Groundwater Transfer Review Summary Form

Transfer/PA # T- <u>13817</u>

O R E G O N WATER RESOURCES D E PA R T M E N T WATER RESOURCES D E PA R T M E N T Oregon Water Resources I 725 Summer Street NE, Suit Salem, Oregon 97301-1271 (503) 986-0900 www.wrd.state.or.us			, Suite A			
Application: T- <u>13817</u>					Applicant Name: Patterson Nursery Sales, Inc.		
Proj	posed Change	es:	□ POA □ USE	⊠ APOA □ POU	$\Box SW \rightarrow GW$ $\Box OTHER$	\Box RA	
Rev	viewer(s): <u>G</u>	abrie	<u>la Ferreira / D</u>	Dennis Orlowsk	<u>i</u> Date of H	Review: <u>November 7,</u>	2023
			Ι	Date Reviewed	by GW Mgr. and	Returned to WRSD: _	
	information sfer may be a	•		plication is insu	afficient to evaluate	e whether the propose	d
	The water well reports provided with the application do not correspond to the water rights affected by the transfer.						
	The application does not include water well reports or a description of the well construction details sufficient to establish the ground water body developed or proposed to be developed.

Application T-13817, Patterson Nursery T2S, R4E, Section 29

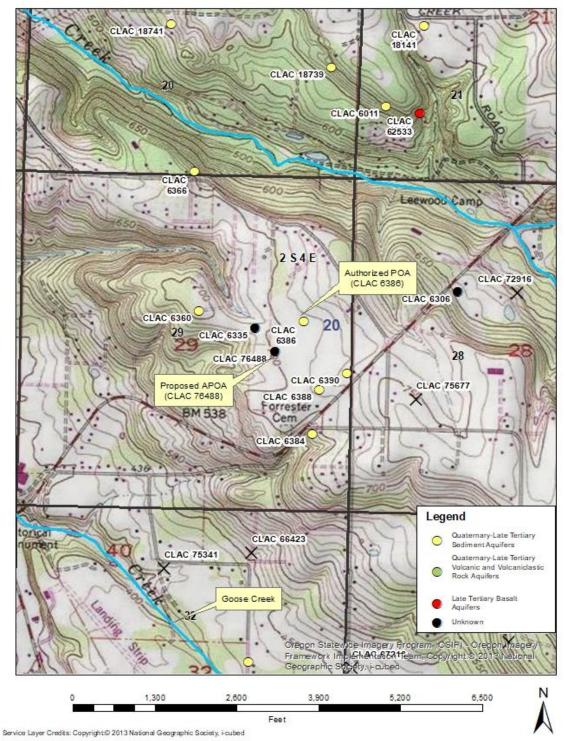
2.	Will the proposed POA develop the same aquifer (source) as the existing authorized POA? Yes No Comments: <u>Authorized POA CLAC 6386 is 200 feet deep and obtains</u> groundwater from water-bearing sand and gravel deposits. Proposed APOA CLAC 76488 is 208 feet deep, located approximately 650 ft southwest of CLAC 6386, and will obtain groundwater from the same sedimentary deposits (Conlon and others, 2005; Swanson and others, 1993).

Yes INO Comments: Relative to authorized POA CLAC 6386, proposed APOA CLAC 76488 is approximately 300 feet nearer to CLAC 6335, a domestic well. This proposed change will likely result in interference with CLAC 6335 and possibly more distant wells.

\boxtimes No If yes, explain: The well nearest to the proposed APOA is CLAC 6335, □ Yes which is 110 feet deep, whereas authorized POA CLAC 6386 and proposed APOA CLAC 76488 are 200 and 208 ft deep, respectively. Therefore, CLAC 6335, in addition to other nearby wells that will likely be affected by the proposed use (e.g., CLAC 6388. CLAC 6390, CLAC 6360) does not fully penetrate the sedimentary aquifer in this area, which the USGS estimates at ~650-700 feet thick (Swanson and others, 1993). Consequently, injury due to the proposed change would not be found because the potentially-affected well(s) do not fully penetrate the shared aquifer (OAR 690-008-0001(8)(c)).

Yes No Comments: Relative to authorized POA CLAC 6386, the location of proposed APOA CLAC 76488 is approximately 700 feet nearer to Goose Creek located to the south and southwest. However, given that these total distances range from about 4100 to 4800 feet between the wells and Goose Creek, it is not likely that the relative proximity of CLAC 76488 will result in an increase in interference with that stream. Furthermore, the 20-30 feet thickness of low-permeability "clay" beginning near ground surface (as recorded on the logs for both wells) will further mitigate potential stream interference.
